SAN ANTONIO WATER SYSTEM WATER SYSTEM CONSTRUCTION Addendum No. 2 To Specifications For Alamo at Guenther Ph II – Water and Sewer Siphon Project SAWS Job No. 12-5046 & 12-5546 Solicitation No. B-13-034-MR

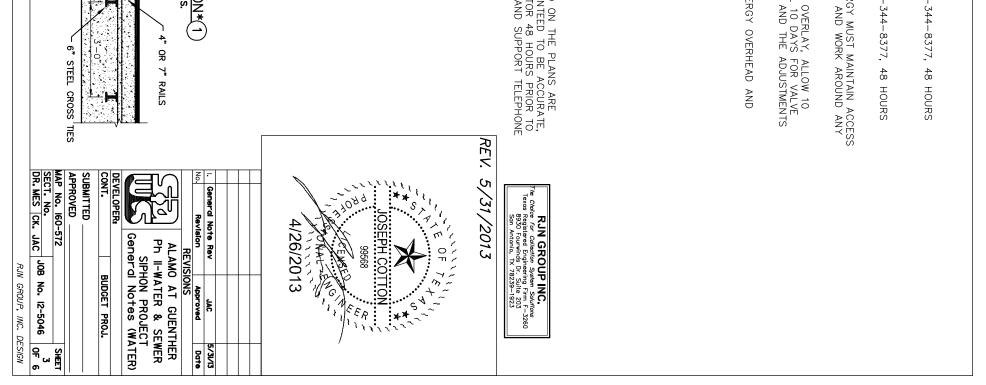
- 11. Water plans sheet 3 of 6 general water note 11: contractor to remove concrete base and steel tracks to be paid under item 2005. There is no bid item 2005 on the bid form.

- k. Item Number 11 was in error. The item should have read "Original paving section for Alamo at Guenther Ph II included 6-18" thick concrete base including steel rails. Contractor must account for the removal of the concrete of varying depths from Sta. 2+30 to Sta. 6+00. Concrete removal shall be paid under Item 101 Preparing Right-of-Way".

10. Any work which is not part of these plans and specifications will not be compensated by the San Antonio Water System without prior approval. 11. Original paving section for Alamo at Guenther Ph II included 6–18" thick concrete base including steel rails. Contractor must account for the removal of the concrete of varying depths from Sta. 2+30 to Sta. 6+00. Concrete removal shall be paid for under Item 101- Preparing Right-Of-Way.
